Federal Register

[Docket No. FAA-2005-22026; Directorate Identifier 2005-SW-05-AD; Amendment 39-14210; AD 2005-16-05]

Airworthiness Directives; Robinson Helicopter Company Model R-22 Series Helicopters

2005-16-05 Robinson Helicopter Company: Amendment 39-14210. Docket No. FAA-2005-22026; Directorate Identifier 2005-SW-05-AD.

Figure 1

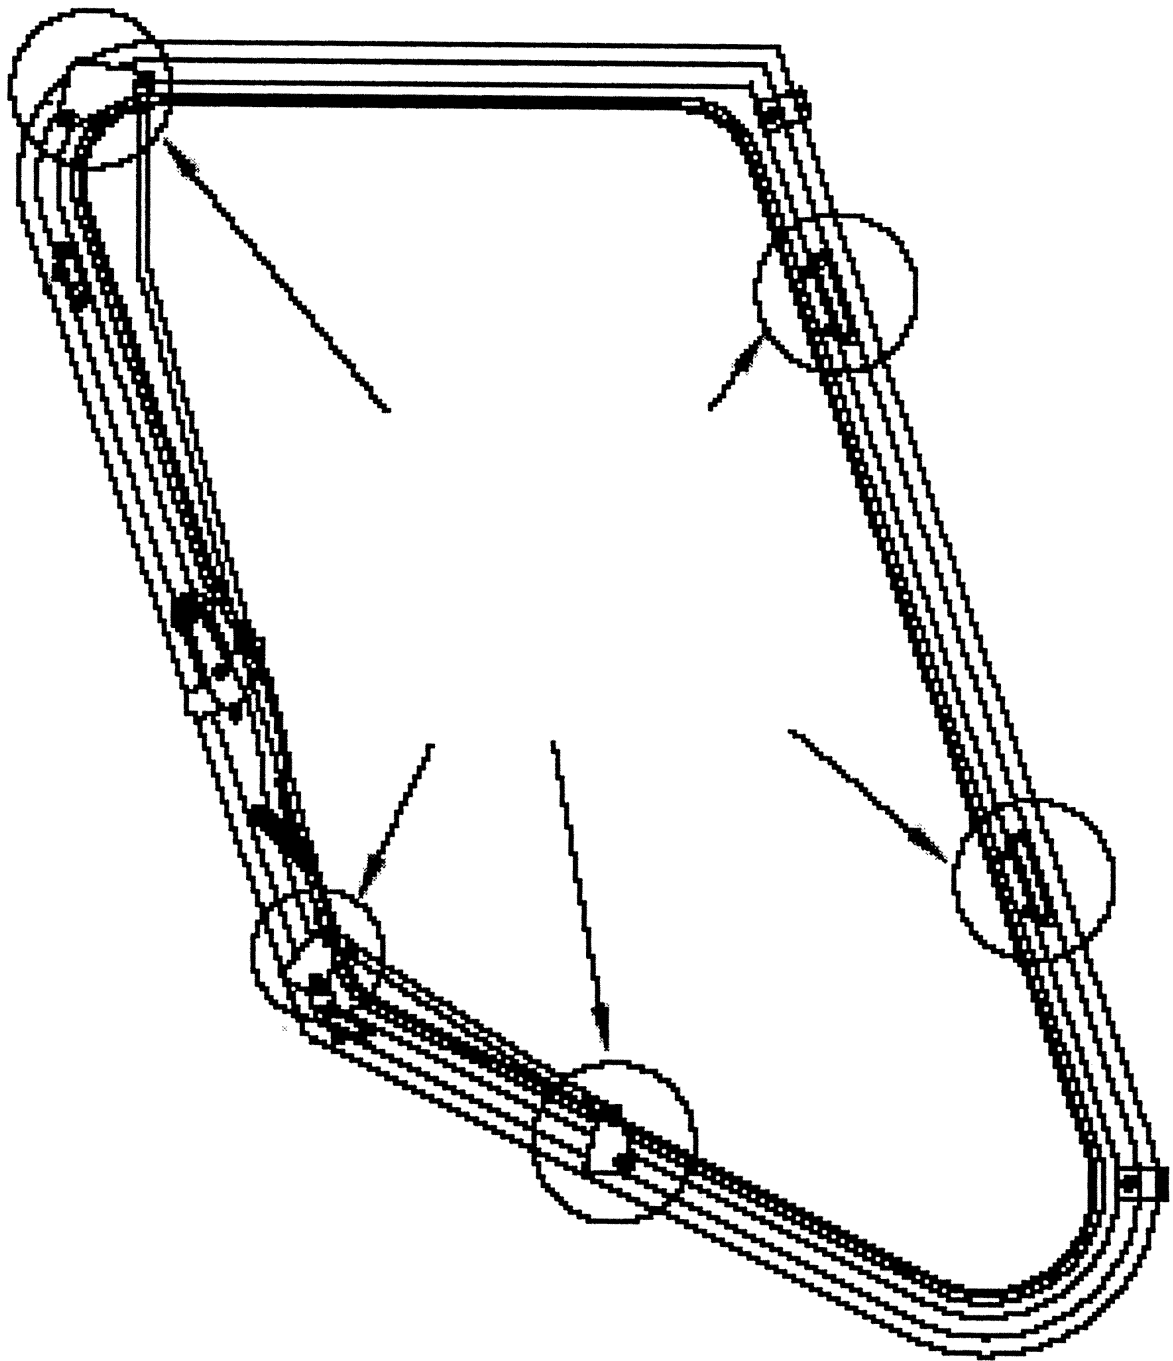
(1) Visually inspect each pilot and copilot door assembly integral frame for a crack in the locations depicted in Figure 1 of this AD. If a crack is found, before further flight, replace the cracked door assembly, part number (P/N) R-22-101-51 or P/N R-22-101-53 (left-hand door assembly), or P/N R-22-101-52 or P/N R-22-101-54 (right-hand door assembly), with an airworthy door assembly. If you use door assembly, P/N R-22-101-51 or P/N R-22-101-53 (left-hand door assembly), or P/N R-22-101-52 or P/N R-22-101-54 (right-hand door assembly) as the replacement, then install it in accordance with Tech-Tool Plastics, Inc. Installation Instructions TTP-1R, Revision A, dated November 21, 1997, and with the sections titled "Door Weather Seal Installation" and "Cotter Pin Installation" in Tech-Tool Plastics, Inc. Service Bulletin No. TTP2005-01, Revision A, dated February 1, 2005 (SB).

(b) After accomplishing the inspections in paragraphs (a) through (a)(2)(ii) of this AD, at intervals not to exceed 100 hours time-in-service, visually inspect each pilot and copilot door assembly integral frame for a crack in the locations depicted in Figure 1 of this AD.

(c) If a crack is found, before further flight, replace the cracked door assembly, P/N R-22-101-51 or P/N R-22-101-53 (left-hand door assembly), or P/N R-22-101-52 or P/N R-22-101-54 (right-hand door assembly), with an airworthy door assembly. If the replacement door assembly is P/N R-22-101-51 or P/N R-22-101-53 (left-hand door assembly), or P/N R-22-101-52 or P/N R-22-101-54 (right-hand door assembly), then install it in accordance with Tech-Tool Plastics, Inc. Installation Instructions TTP-1R, Revision A, dated November 21, 1997, and "Door Weather Seal Installation" and "Cotter Pin Installation" sections of the SB.
